Strategic advice on the proposed buffer for the Woodman Point Wastewater Treatment Plant

**Section 16(e) report and recommendations
of the Environmental Protection Authority**

**Environmental Protection Authority
Perth, Western Australia
Bulletin 1240
November 2006**

Figure 2.1 Predicted odour contours for the existing (nominally 120 MI/day) WWTP using the model setup from CEE (2005a). All odour survey points included.

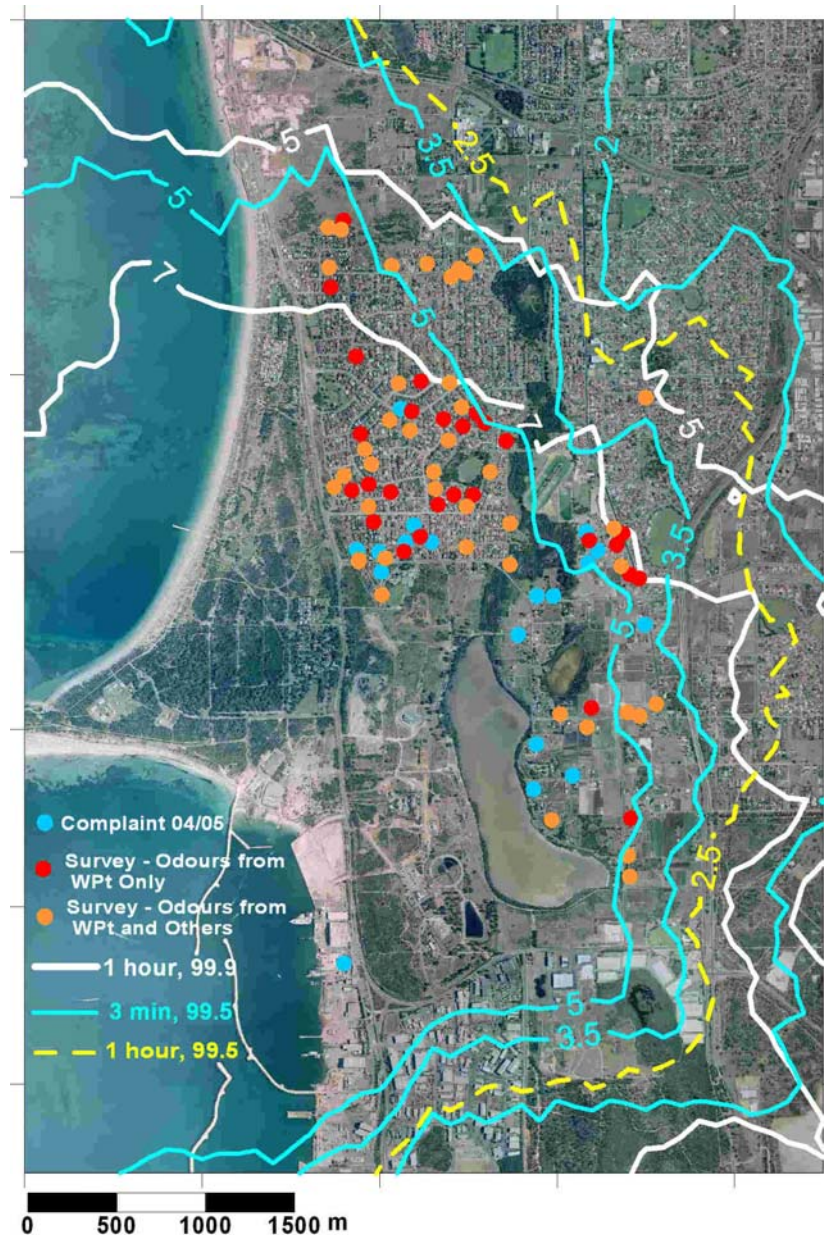
- The agreement between the above criteria and the complaint data at Woodman Point is not good (see Figure 6, Annexure G) with the contour extending 1km further than the data in the east direction and a good 0.5 km east of Rockingham and Stock roads where no complaints were plotted. This agreement becomes even weaker when it is noted that incorrect plots were presented in the SER, being based inadvertently on sigma theta dispersion and not Pasquill Gifford (PG) dispersion curves as intended (CEE, 2005b). With the use of the PG dispersion curves, the contours extend further (see **Figure 2.1**). The “good” agreement only occurred in the 2003 modelling (see Figure 4 of CEE (2003)) and the accompanying text when using both the Hope Valley wind data and incorrectly using measured standard deviation of wind direction for dispersion (see **Section 2.7** for more details).

Also this “good” agreement in CEE (2003) was due to the omission of the northern-most odour survey data. Comparison of the survey data (last page of Annexure C in the SER) with that used in the model validation exercise (Figure 6, in Annexure G of the SER), indicates that all data points north of Amity Boulevard were excluded (the top 14 points in **Figure 2.1**). Inclusion of these points and modelling with the correct PG curves (see **Figure 2.1**), indicates that the 50u 1-hour 99.9th percentile provides a good fit (encompasses) the data to the north, but over-predicts the area with complaints to the east by 1 to 1.5 km.

Instead of the 99.9th percentile contour shape providing the best agreement, the 99.5th percentile provides a better fit as seen in **Figure 2.1**. For this percentile and averaging period, the 3.5 ou level shows a good fit just encompassing the survey data to the north and east. The 5 ou, 3 minute 99.5 criteria, which was in the original commitment and licence condition (see **Appendix B**), slightly under-predicts the “affected” area from the survey, but is a better predictor than the 5 ou, 1 hour 99.9 percentile. That the 99.5 percentile is a better fit to the survey data is due to it better reflecting the frequency of light wind, stable conditions. Use of a higher percentile (eg 99.9 percentile) will tend to provide a more circular contour. PAE in the WWTP odour buffer review (PAE, 2005a) conclude that a 99.5 percentile is better than the 99.9 percentile and that a lower percentile such as the 98th to 99th percentile is probably optimum in matching odour annoyance.

Figure 2.2 Predicted 3 minute 99.5th percentile odour levels (ou) from the existing Woodman Pt WWTP

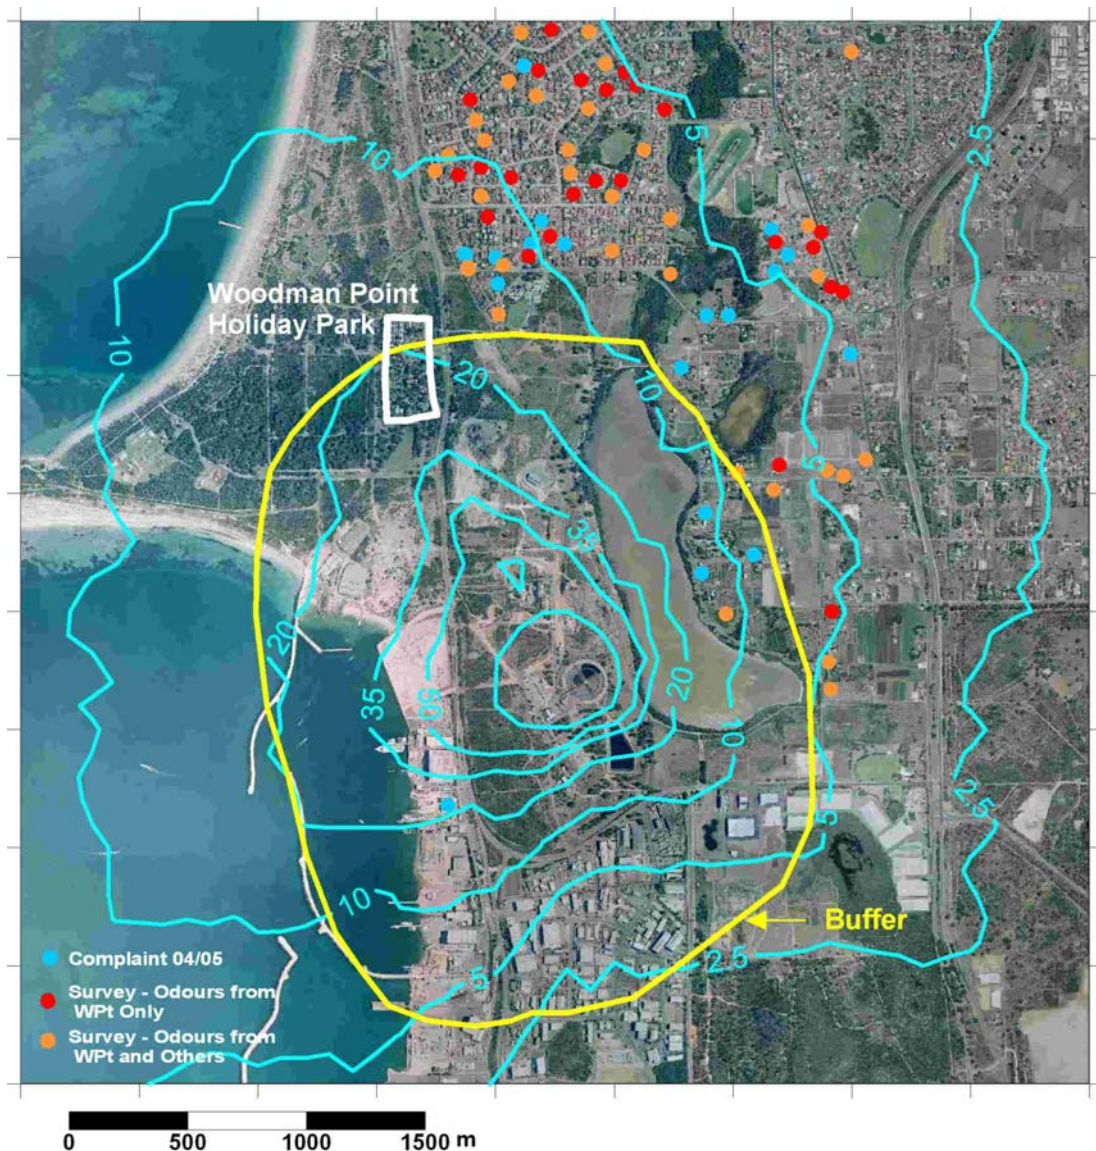
The study omits to identify the Woodman Point Holiday Park as an odour sensitive premises as per the DoE definition of odour sensitive premises (EPA, 2002). This holiday park extends 300m inside the buffer zone (see **Figure 2.2** for the location), with 200 permanent residents and up to another 200 visitors in peak times (pers com, Park Manager). According to **Figure 2.2**, this area of residences would be more affected by odours than the two locations which are discussed as the worst affected areas with residences (South Coogee and the area to the east of Lake Coogee). For example, at the south east corner of the holiday park, the existing 99.5th percentile 3 minute average odour level is 27 ou compared to a predicted 15 ou at the southern-most residence in South Coogee and the east edge of Lake Coogee.

As this holiday park is the most impacted odour sensitive premises, it should be the focus of the report and how the odour management plan will reduce odours to acceptable levels there. This area was not included in the odour survey and according to the SER did not register any odour complaints in the reporting period. However, in a petition circulated around June 2004 by Robyn O'Brien and sent to the Chair of the EPA, there were 41 signatories from the park's residents who had "experienced odours from the WWTP" and "requested" Water Corporation to reduce the odour buffer". Also, it was reported that during the gathering of signatories that several of the residents noted that they had made complaints in the past about the odour there (Murray O'Brien, pers comm., 2006). These complaints may not have been sent to the Water Corporation or perhaps were outside the period that Water Corporation used for the complaint data in **Figure 2.2**.

Figure 2.3 Odour and Flow Rates to the PST/Inlet Scrubber

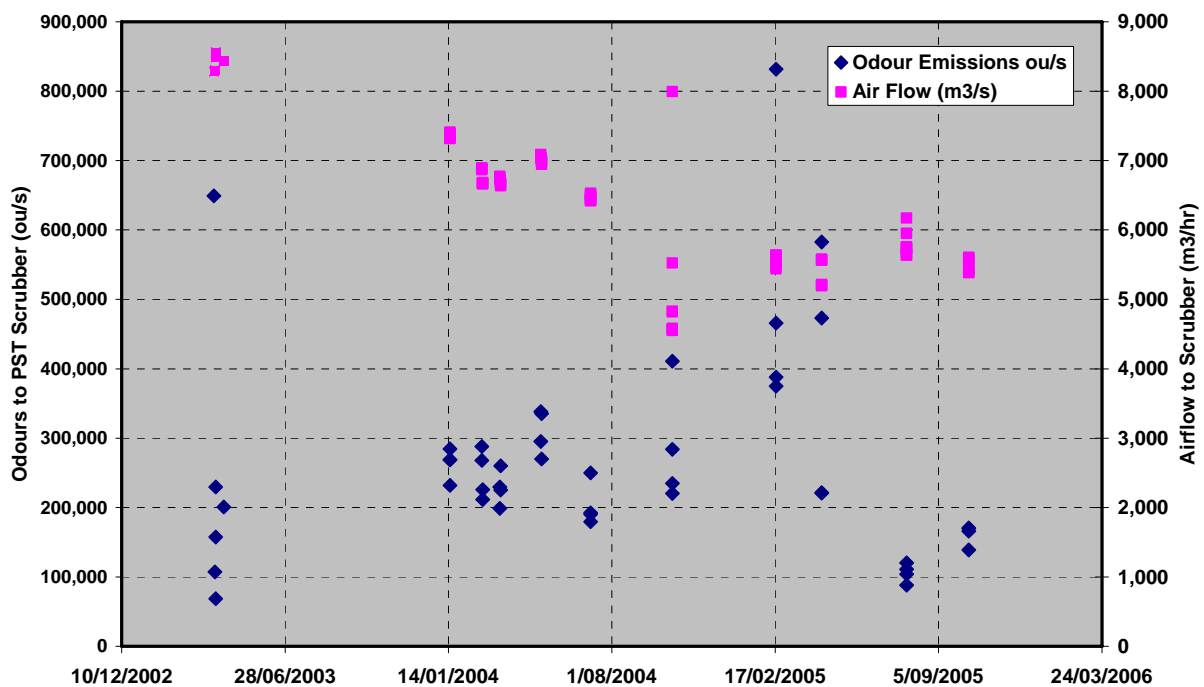
- Fugitive emissions from the PST and inlet areas of 20,000 and 6000 ou/s each. These are estimates based on an estimated 5% fugitive emission from the PST covers and was subjectively assessed from the 2003 survey visit. These again could easily be higher or lower with the actual value being quite dependent on the number of covers that are off the PST tanks, the extraction rate of the scrubber fan at the time and wind conditions. It is noted that the extraction air to the PST has been decreasing with time (see **Figure 2.3**) and as such, the fugitive emissions from this area may be generally increasing.

- PST/inlet Scrubber. The odour concentrations and emissions to the scrubber are quite variable **Figure 2.3** with estimated emissions ranging from 88,000 to 830,000 ou/s with a 75th percentile emission of 290,000 ou/s (note no odour decay corrections have been applied). The PST/Inlet scrubber outlet emissions have ranged from 490 to 22,000 ou/s with a 75th percentile of 3,400 ou/s. The outlet measurements indicate agreement with the 20,000 ou/s assumed in the monitoring, but it appears that there has been no monitoring during an event with H₂S breakthrough. For this, a continuous H₂S monitor is required; and
- The clean TEQ bio-filter record much lower odour emissions than sampled in 2003, with the emissions ranging from 190 to 450 ou/s with a 75th percentile odour emission of 380 ou/s. The 2003 samples used in the modelling resulted in an odour emission rate of 22,300 ou/s, indicating

Figure 3.1 Predicted 3 minute 99.5th percentile odour levels (ou) for the 240 ML/d Woodman Pt WWTP

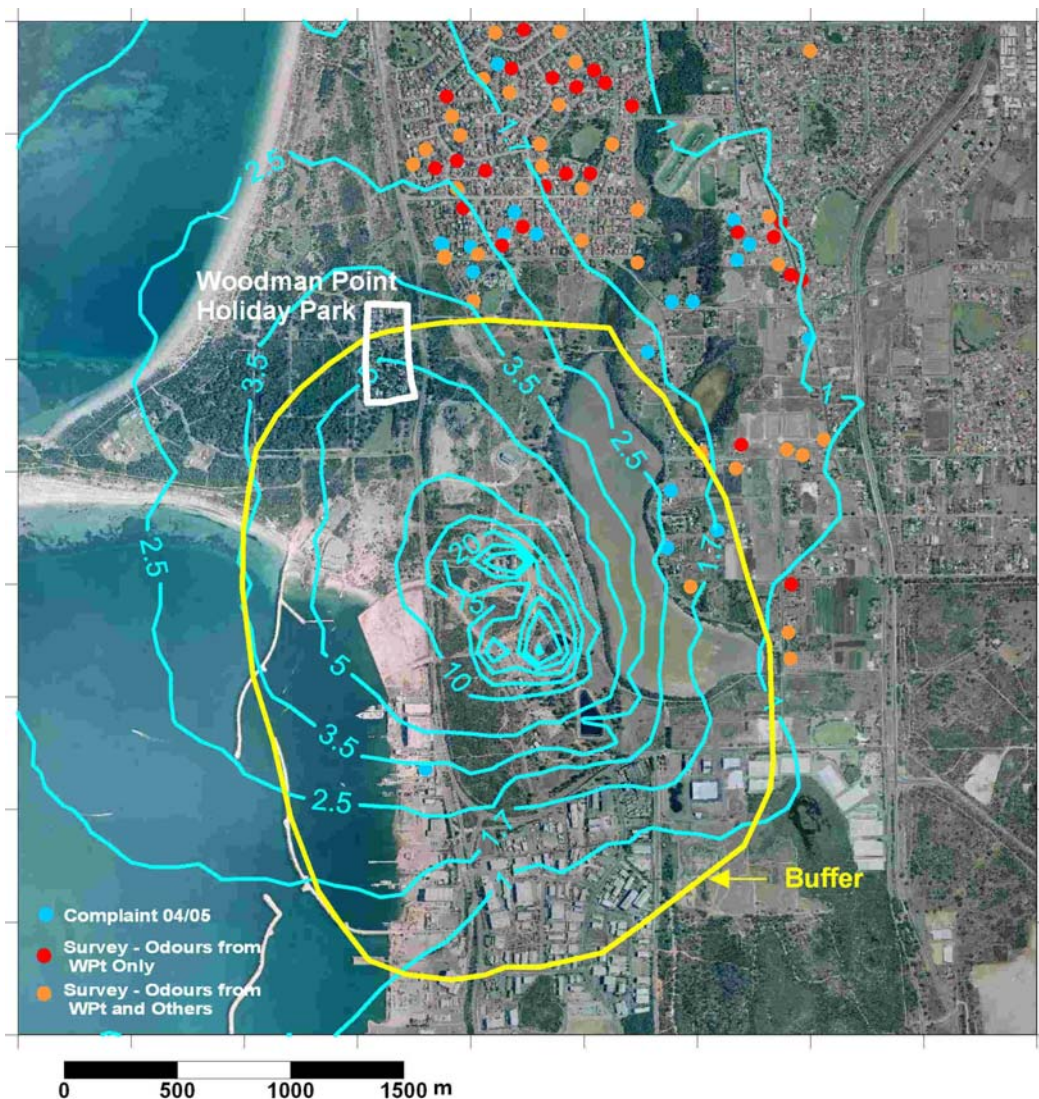
For comparison to the odour contours presented in the SER and the argument that the buffer needs to be retained, **Figure 3.1** presents the predicted odours at 240ML/d but for the 3 minute 99.5 percentile criteria.

Using the 3.5 ou as presented in **Figure 2.2** as a good measure of the extent of odour complaints/annoyance, at 240 ML/day, the 3.5 ou level is just achieved at South Coogee with the contour not extending to the eastern edge of Lake Coogee, though with concentrations above this throughout the entire Woodman Point Caravan Park. Noting there are concerns with the emissions, modelling assumption and neglect of intermittent emissions, the results in **Figure 3.1**:

Figure A.1 Scatter plot of Woodman Point versus Hope Valley Wind speeds

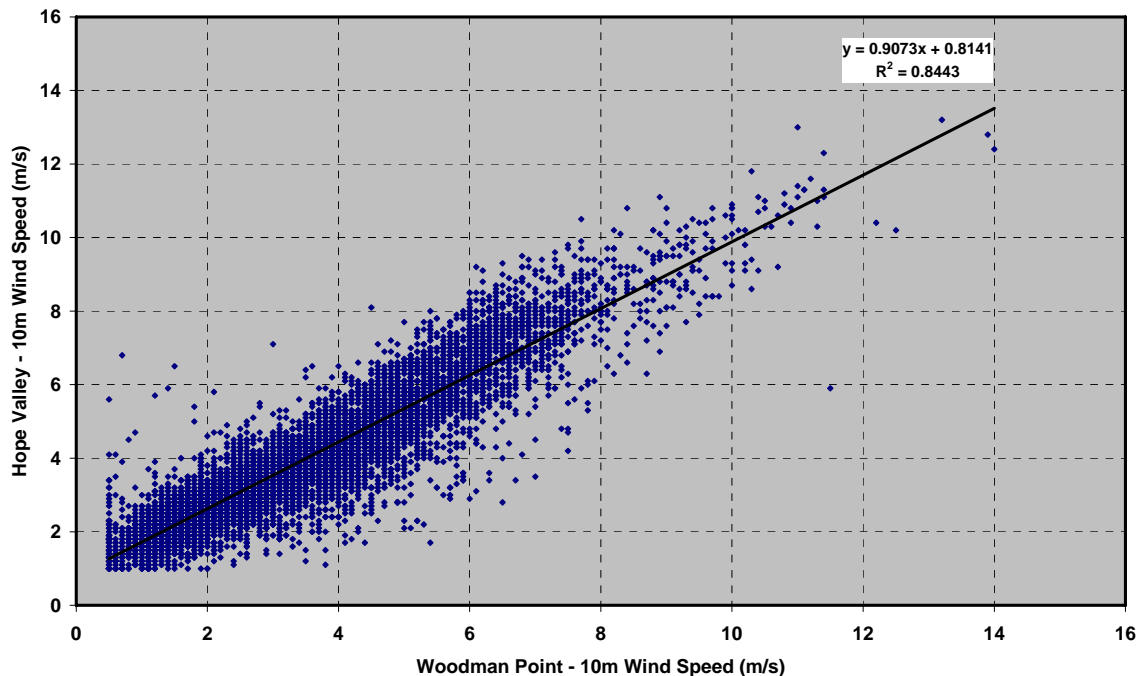
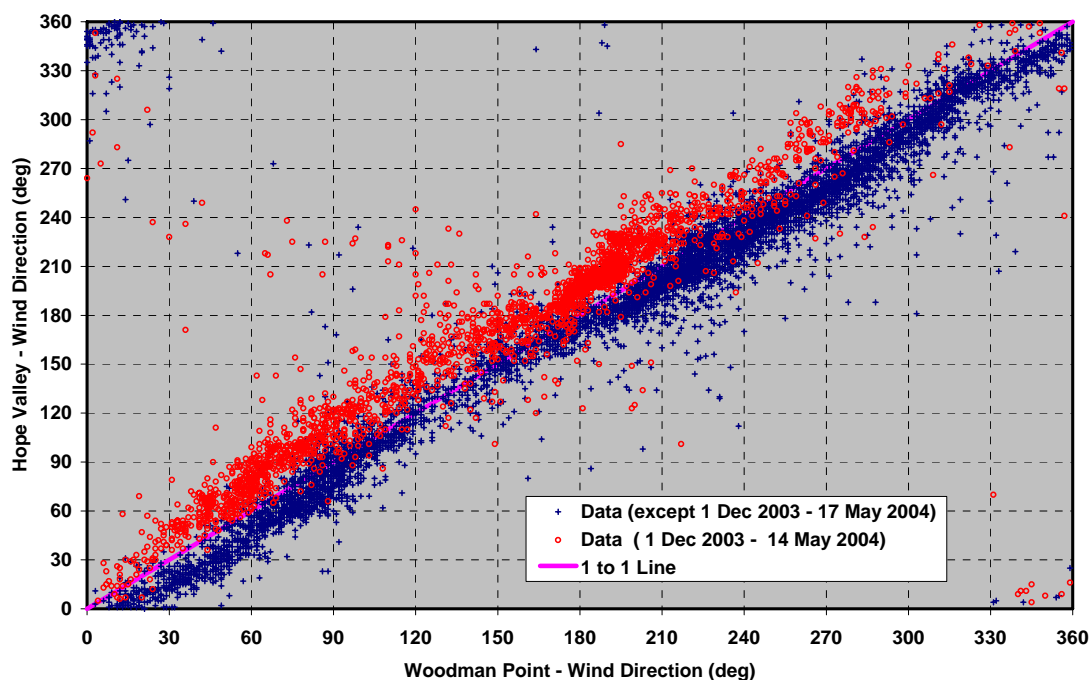
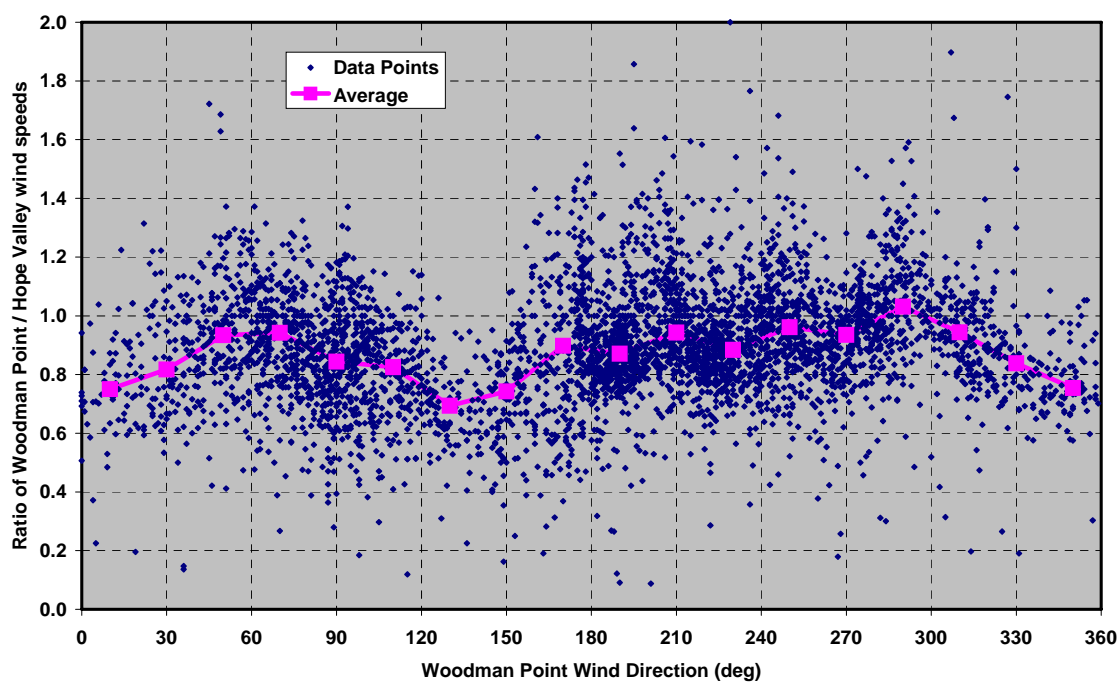
Selected plots of the comparison between the wind speeds and directions between the two sites are presented in **Figure A.1** to **A.3** indicating:

- The wind directions for three days are incorrect (midday 14th to 17th May 2004) with the wind directions being reversed around 180 degrees; and
- 1 February 2005 is suspect being the wrong date or bad data.

Therefore, the Woodman point data set looks reasonable for the site, with some under measuring of south easterlies and northerlies which are not critical in terms of determining odour buffers. The data does however, have some issue with a wind direction problem for a period of 5 months which should be corrected and there are 4 days of data with wind direction errors that also should be fixed before other modelling is conducted.

Figure 1 Comparison of Predicted 3.5 OU Contour by CEE and Air Assessments, and Recorded Odour Complaints and Concerns

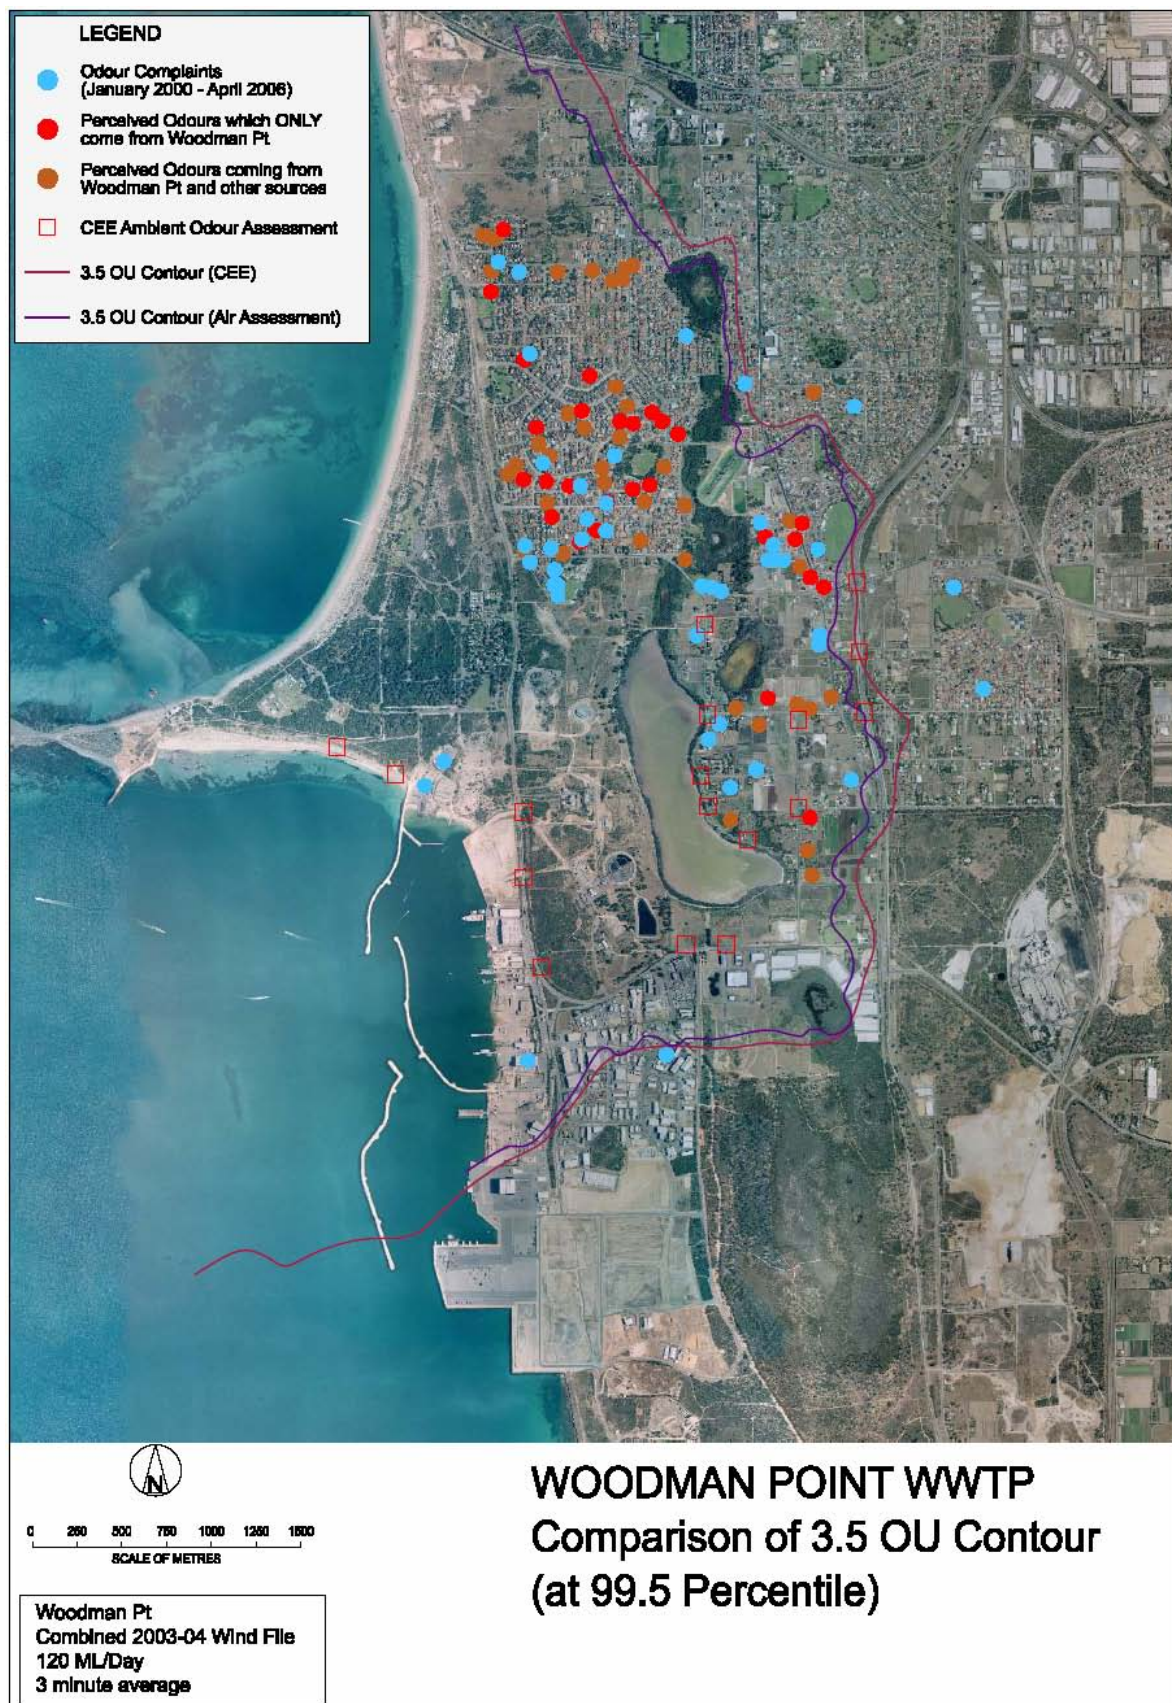
Figure 1 shows the **3.5 OU contour, as predicted by the reviewer**, plotted on a plan of the area, together with all known odour complaints from January 2000 to April 2006, all responses from the phone survey in September 2003 and sites recorded in CEE field surveys as having noticeable odour.

The two blue dots east of Stock Road on Figure 1 denote formal odour complaints and indicate that an odour level, which some residents consider to be unacceptable, extends east of Stock Road. Based on this evidence, the Water Corporation considers that unacceptable odour impacts are currently experienced by residents east of Stock Road. However the 3.5 OU contour recommended by the reviewer does not extend east of Stock Road.

It can be seen in Figure 1 that the 3.5 OU contour predicted by the reviewer does not encompass 5 sites reporting odour complaints, and excludes any odour impacts east of Stock Road, which is clearly not in accord with the evidence. Thus the Water Corporation considers that the 3.5 OU contour significantly under-estimates the extent of the odour impact experienced by the community.
